**STAFF REPORT**  
**COMMUNITY DEVELOPMENT DEPARTMENT**

DATE: 4/6/2021  
 TO: Mayor & City Council  
 FROM: Joseph Dodson, Associate Planner  
 208-884-5533  
 SUBJECT: FP-2021-0009  
 Teakwood Place Final Plat

# B. Final Plat (dated: January 23, 2021)

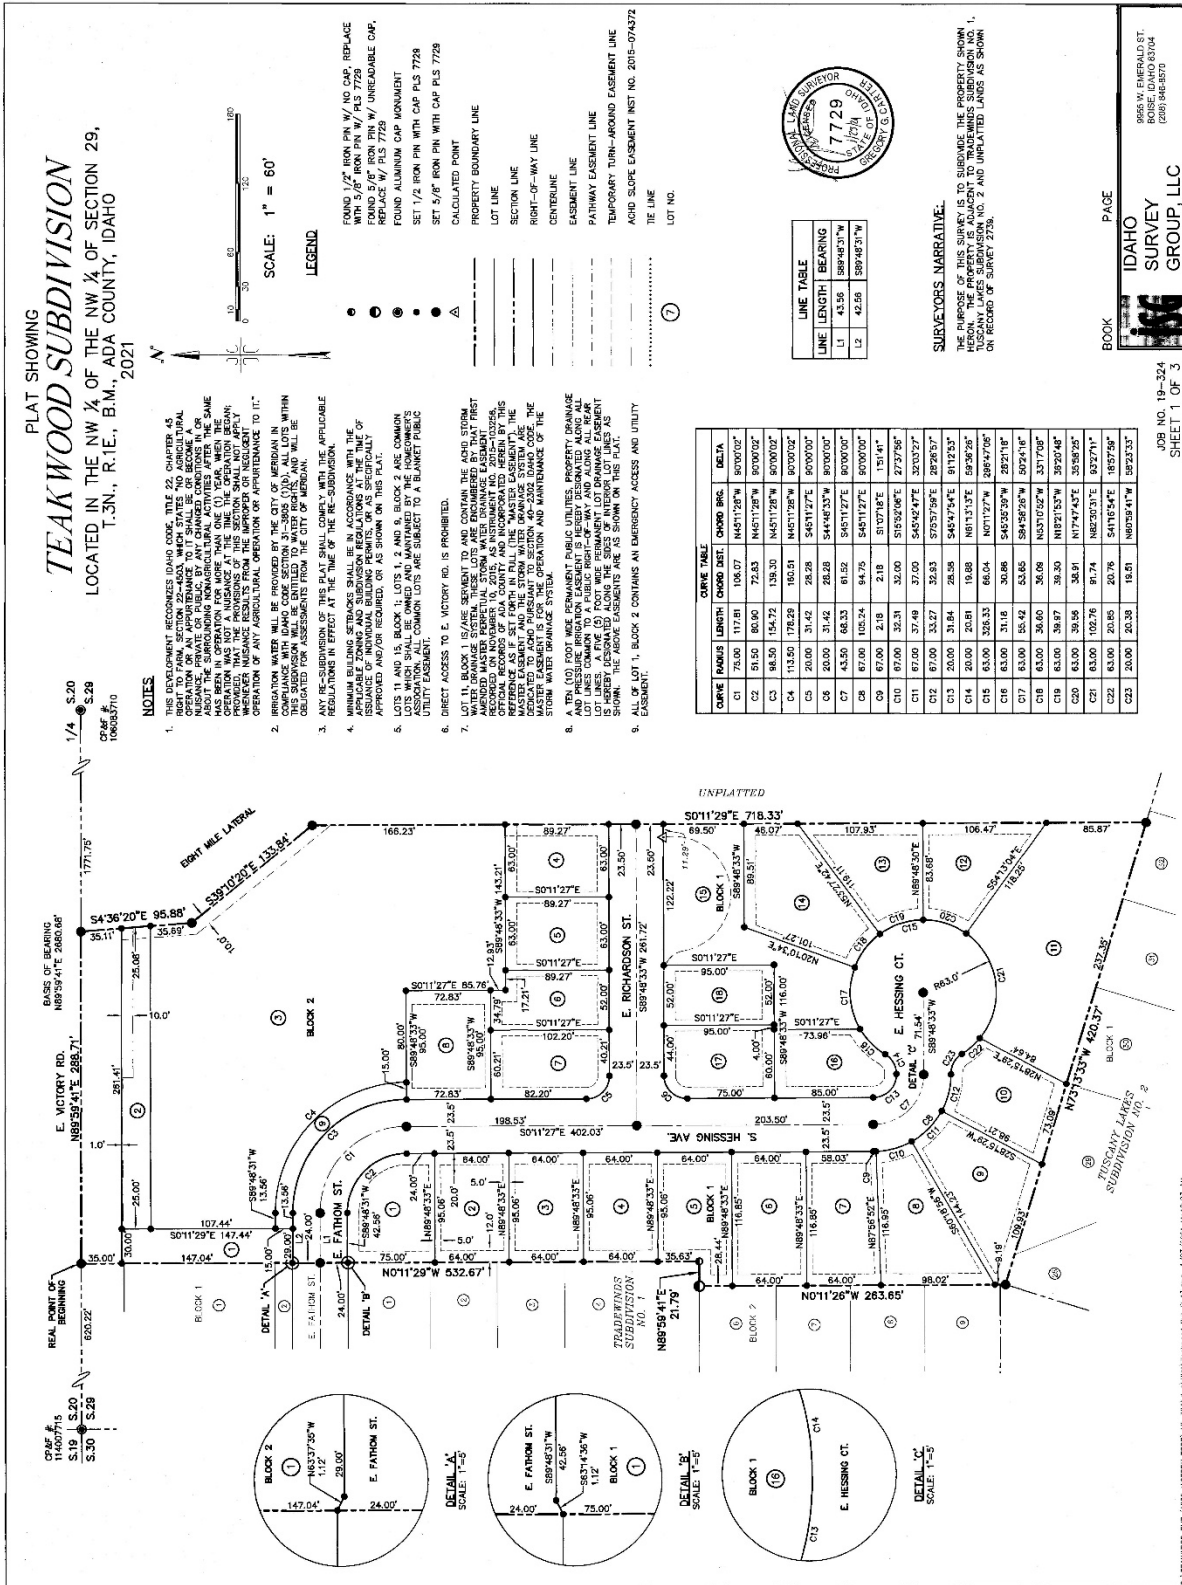
- a. Add a note stating: "This development is subject to the City of Meridian Development Agreement, Inst #2021-002167."
  - b. **The R-8 zoning district requires a minimum street frontage of 40-feet; the home that is remaining on Lot 3, Block 2 is required to have this minimum street frontage. Revise the plat to show the required street frontage along the curve of E. Fathom Street as it heads south—staff recommends this occur in the area closest to Lot 8, Block 2 where the new driveway is proposed. Lot 9, Block 2 should be reduced in size to ensure Lot 3, Block 2 has the minimum street frontage.**

- c. Add a note that Lot 3, Block 2 contains a pedestrian access easement along its northeast property line and include the recorded instrument number.

- d. Revise the street names on the plat per the Ada County Street Name Review response letter.
  - e. Add a note stating: The bottom of structural footing shall be set a minimum of 12-inches above the highest established normal ground water elevation.

- f. Add a note stating: Maintenance of any irrigation and/or drainage pipes or ditches crossing a lot is the responsibility of the lot owner unless such responsibility is assumed by an irrigation/drainage entity or lot owner's association.

- g. Revise Note #2 to name the appropriate irrigation district instead of "The City of Meridian."
5. Prior to signature on the final plat by the City Engineer, the landscape plan prepared by Leavitt & Associates Engineers, Inc. (Exhibit C), dated November 16, 2020, shall be revised as follows:

C. Landscape Plan (dated: November 16, 2020)

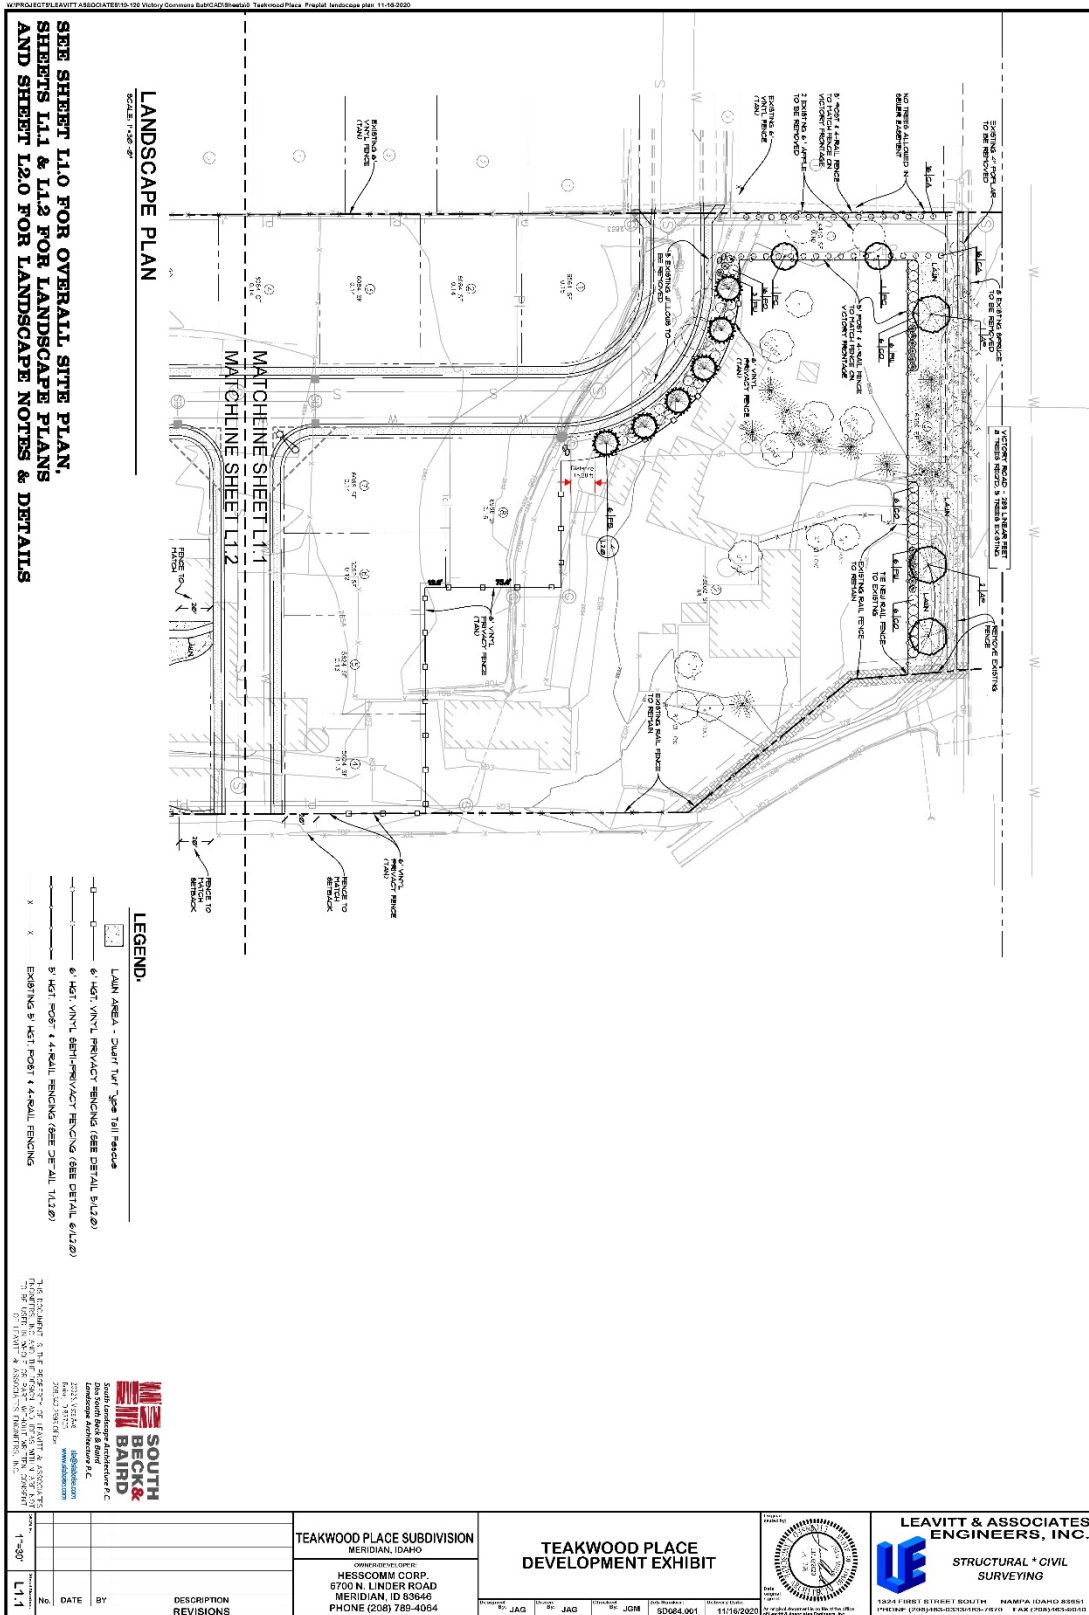
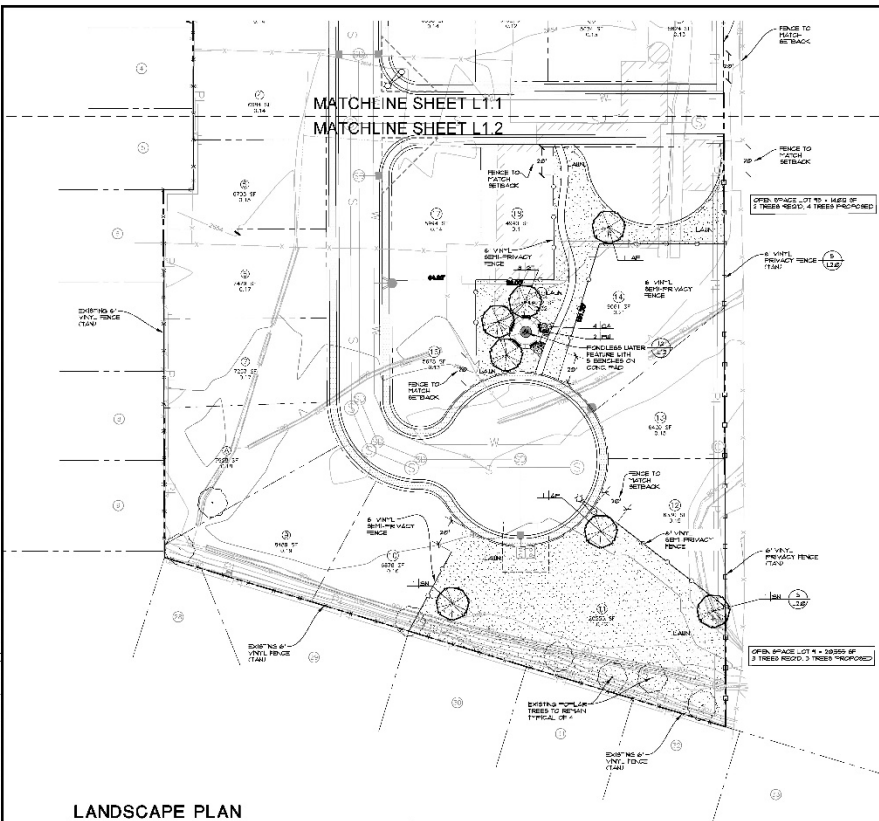
- a. Show the required street frontage along E. Fathom Street to match the requirement of the plat.
6. Any structures that remain on the property (Lot 3, Block 2) must comply with the dimensional standards of the R-8 zone or they must be removed.
